Thank you for purchasing the PG-FP5 flash memory programmer.

This document describes specifications that have been added or changed, restrictions, and cautions on using the PG-FP5. Also see the user's manual of the PG-FP5 for terminology and points for caution on using the PG-FP5.

## Chapter 2 Additions and Changes to Specifications

### No. 1 Modification of **Cancel** button specification

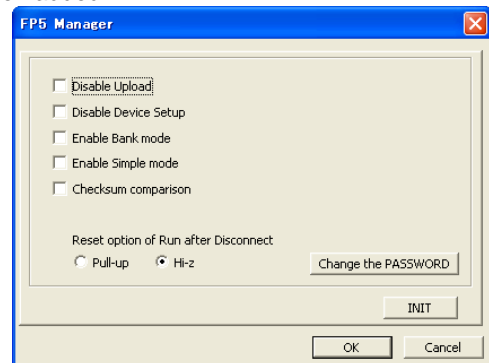
**Description:** The function of the **Cancel** button on the PG-FP5 main unit has been modified so that cancellation, which was applied to all commands, is only applied to the **Read** command.

#### No. 15 Addition of **Wide Voltage mode** function

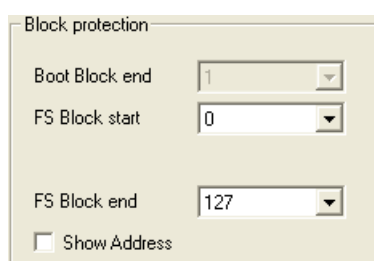
**Description:** The **Wide Voltage mode** check box has been added to the **Command options** area. If this check box is selected, commands are executed in the wide voltage mode. If this check box is not selected, commands are executed in the full-speed mode. This check box is available when a device supporting this function is selected. For details about the wide voltage mode and full-speed mode, see the user's manual of each device.

#### No. 16 Change of layout in **Block protection** area

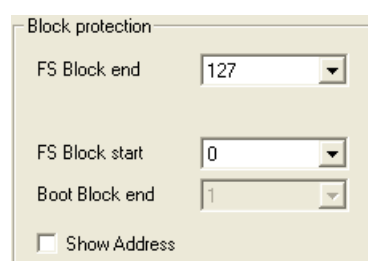
**Description:** The layout in the **Block protection** area has been changed.

#### No. 25 Change of supported Windows Versions

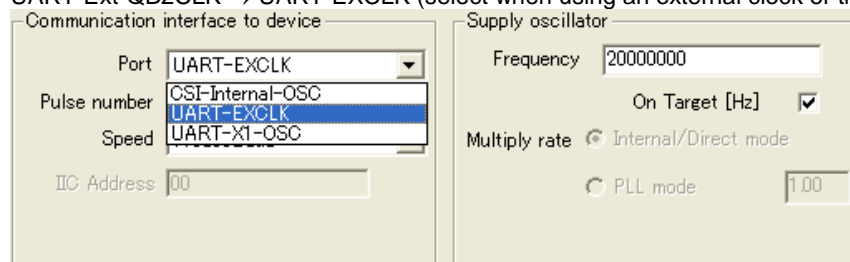
**Description:** The 32-bit and 64-bit editions of Windows 7 and the 64-bit edition of Windows Vista are now supported. Windows 2000 is no longer supported.
